Access Compliance Report

Public Rights-of-Way

(Curb Ramps)

Intersection ID: 23104	Main Street: PENSFORD_LN	Cross Street: LYNBRIDGE_DR	Location: SE
ADA ID: ADD68EF91C64	Ramp Type: PerpDiag	Initial Pass/Fail: Fail	Overall Compliance: No
Severity Score: 46.25			
Codes/Mitigation Info/Possible Solution		Field Measurements/Component Compliance

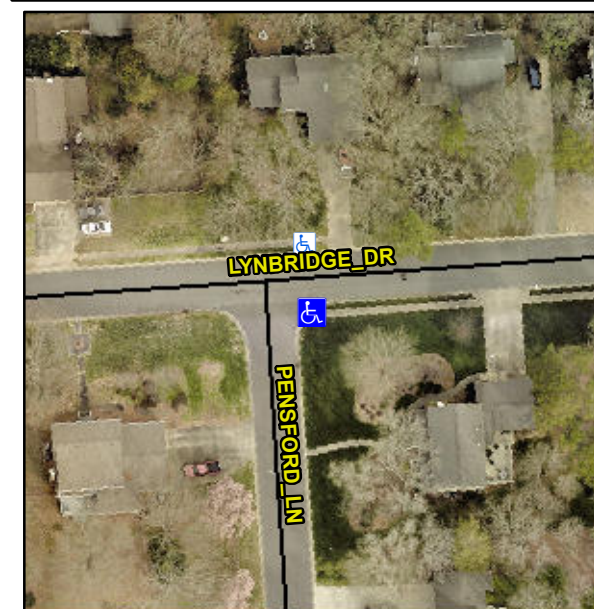
R304.5.1, R304.2.2, R304.5.3

Compliance	Description	Data	Compliance	Description	Data
N/A	Ramp Length (in)	38.5	No	Ramp Slope (%)	13.6
No	Ramp Width (in)	39.0	No	Ramp XSlope (%)	6.0
N/A	Flare Type LT	N/A	N/A	Flare Type RT	N/A
N/A	Flare Slope LT (%)	N/A	N/A	Flare Slope RT (%)	N/A
N/A	Flare Traversable LT?	N/A	N/A	Flare Traversable RT?	N/A
N/A	Landing Length (in)	N/A	N/A	DWS Provided?	N/A
N/A	Landing Width (in)	N/A	N/A	DWS Contrast?	N/A
N/A	Landing Slope (%)	N/A	N/A	DWS Length (in)	N/A
N/A	Landing X Slope (%)	N/A	N/A	DWS Full Width?	N/A
N/A	Landing Curb? (Y/N)	N/A	N/A	DWS Offset (in)	N/A
N/A	Shared Landing?	N/A			
N/A	Gutter Ponding?	N/A	N/A	Gutter Slope (%)	N/A
N/A	Gutter Lip Ht (in)	N/A	N/A	Gutter X Slope (%)	N/A
N/A	Painted X Walk1?	No	N/A	Painted X Walk2?	No
	X Walk 1 Direction	To N		X Walk 2 Direction	To W
N/A	X Walk 1 Width (in)	N/A	N/A	X Walk 2 Width (in)	N/A
	X Walk 1 Slope (%)	1.2		X Walk 2 Slope (%)	4.3
	X Walk 1 X Slope (%)	5.6		X Walk 2 X Slope (%)	0.0

Remove & Replace Curb Ramp With Two New Directional Ramps or Equivalent.
